Nomination Form
Anadromous Waters Catalog

Name of Waterway 10 Mile Creek USGS Name Local Name

Nomination #	<u>14-585</u>	<u>James J. Hasbrouck</u>	<u>9/3/2014</u>
		Fisheries Scientist	Date
Revision Year:	<u>2015</u>	<u>[Signature]</u>	<u>9/3/14</u>
		Habitat Operations Manager	Date
Revision to:	Atlas _____ Both <input checked="" type="checkbox"/>	<u>[Signature]</u>	<u>7/22/14</u>
		AWC Project Biologist	Date
Revision Code:	<u>C-9, D-2</u>	<u>TQ</u>	<u>9/17/14</u>
		Cartographer	Date

Figure 1. – 10 Mile Creek Route Correction Map.

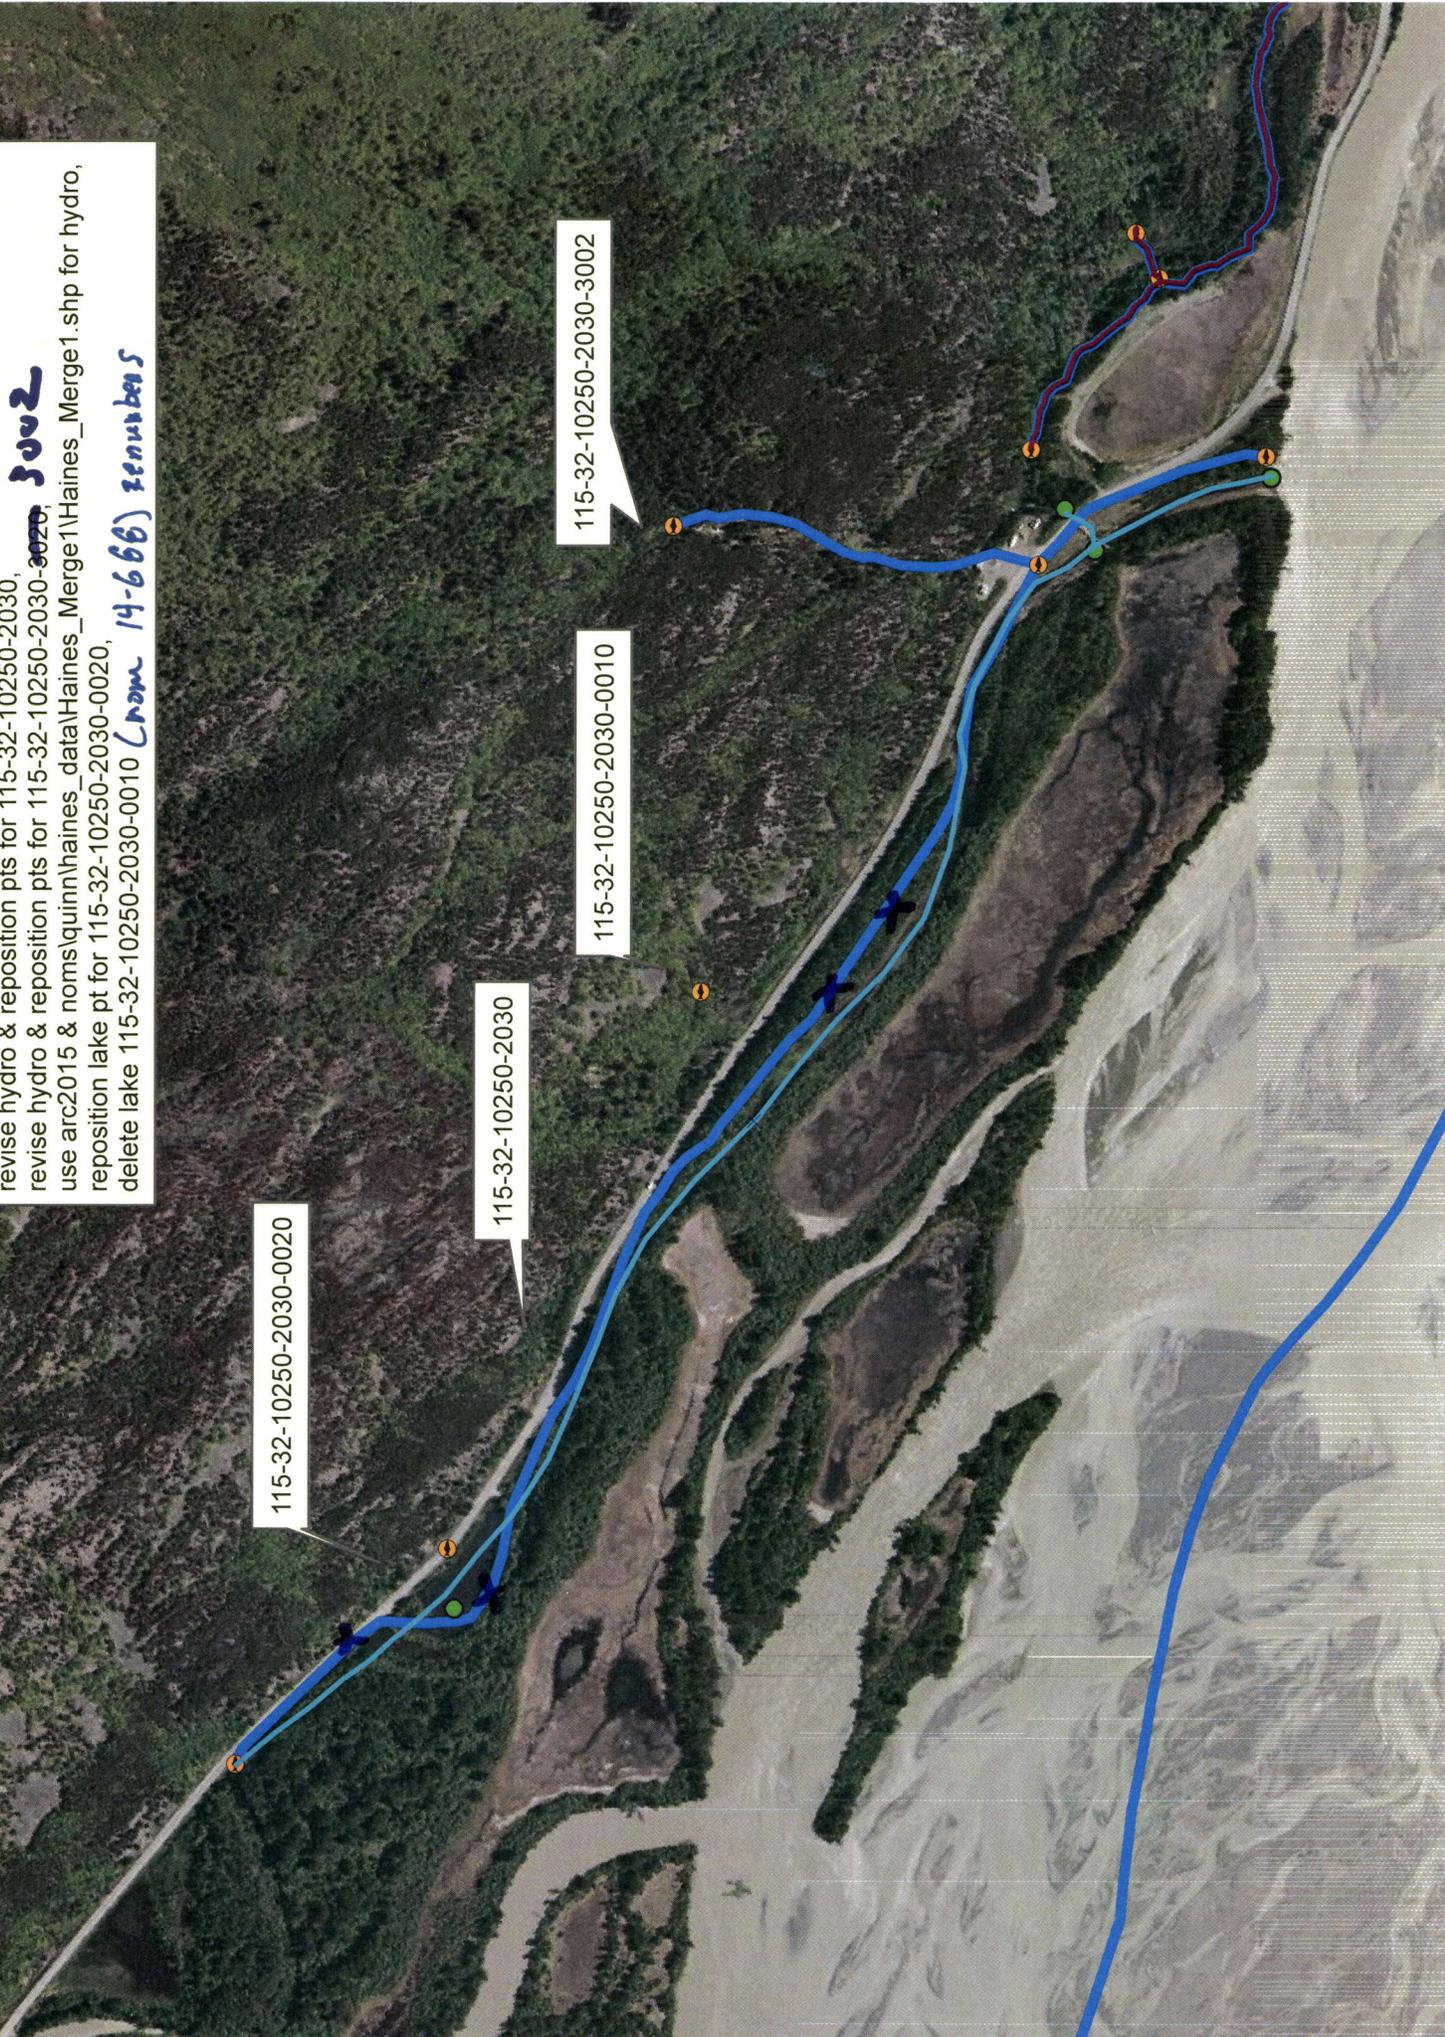
Please update this stream to reflect the field-verified route, upper, and lower extents. Also, a slight shift to 10 mile slough would make the arcs line up at the lower point.

Update hydrography & reposition pts for 115-32-10250-2030 9
2030-3002, Reposition lake pt 115-32-10250-2030-0020

delete lake 115-32-10250-2030-0010
Date: 06/19/2014

10 MILE CREEK**Water body name:** 10 Mile Creek**Water body number:** 115-32-10250-2030-3002**Watershed:** Chilkat Inlet**Findings:** We found that this stream is significantly shorter than illustrated in the Catalog. There is a hydro just above the Haines highway that prevents fish passage.**Recommendations:** I recommend that this stream be shortened to reflect the actual upper limit to anadromy at the hydro at waypoint 16.**ROUTE CORRECTION****Survey date:** 7/6/2011**Species & Lifestage:** CHs, COr, Ps, DVr**MTR:** C030S058E **Quad:** Skagway B-2

revise hydro & reposition pts for 115-32-10250-2030,
revise hydro & reposition pts for 115-32-10250-2030-3002,
use arc2015 & noms\quinn\haines_data\Haines_Merge1\Haines_Merge1.shp for hydro,
reposition lake pt for 115-32-10250-2030-0020,
delete lake 115-32-10250-2030-0010 *(from 14-666) renumbers*
